**From:** Kathryn Balachandran <kbalachandran@ksinghengineering.com>  
**Sent:** Friday, February 21, 2025 11:12 AM  
**To:** Gray, Jane K - DNR  
**Cc:** Shane LaFave; Que El-Amin (que@scott-crawford.com); Pratap Singh; Angy Singh  
**Subject:** RE: CWC East Block (02-41-263675) - Information Requested  
**Attachments:** 4 - CWC-EB\_Round 4\_Table 3 w CCV and ICAL.pdf; 1 - CWC-EB\_Round 4\_Passive Sampler Log.pdf

**From:** Gray, Jane K - DNR <[jane.gray@wisconsin.gov](mailto:jane.gray@wisconsin.gov)>  
**Sent:** Wednesday, February 12, 2025 1:25 PM  
**To:** Pratap Singh <[psingh@ksinghengineering.com](mailto:psingh@ksinghengineering.com)>  
**Cc:** Angy Singh <[angy.singh@ksinghengineering.com](mailto:angy.singh@ksinghengineering.com)>; Shane LaFave <[Shane@roerscompanies.com](mailto:Shane@roerscompanies.com)>; Que El-Amin <[que@scott-crawford.com](mailto:que@scott-crawford.com)>  
**Subject:** CWC East Block (02-41-263675) - Information Requested

Hi Dr. Singh – As I mentioned in my voicemail just now, the DNR has reviewed the *Fourth Round of Commissioning* (Report), submitted on January 20, 2025, for the subject site. The following information is required before the DNR can i

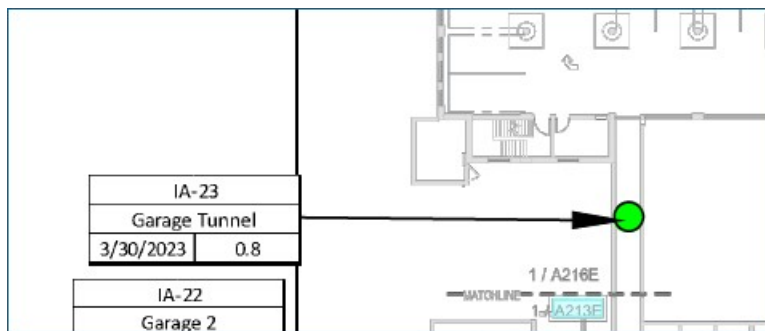
CWC's *Response to WDNR Review of Site Investigation Report*, dated March 1, 2022, indicates that the tunnel beneath the central courtyard has been sealed from the south end and was proposed to be used for maintenance supplies to be accessed from the northern end of the tunnel, which opens to the ventilated underground parking garage. During the DNR's site visit on February 4, 2025, K. Singh staff was not aware of the status or location of this tunnel. The March 1, 2022, report indicates that indoor air sampling in this tunnel would occur as a part of the commissioning process. Clarify whether this tunnel is still accessible from its northern end, what it is or will be used for, and whether any indoor air data was collected from this tunnel during commissioning. Provide the indoor air data from this tunnel if it is available. If it is not available and if the tunnel is accessible and will be used by CWC staff, then collect an indoor air sample from the tunnel to confirm that the indoor air is below the vapor action levels (VALs). You may choose to first screen the location using the portable GC unit on-site to help determine if any additional sampling is necessary in this location.

The tunnel was closed at the south end during early stages of construction and is no longer used as a route of travel between buildings. The tunnel is not in use, and it is inaccessible behind a locked door on the north end. Testing from Stairwell 7 Room 1089 immediately adjacent and the NW garage show no indoor air risks in this area.

Testing was previously performed in March 2023, and no VAL exceedances were noted in the tunnel. See below.
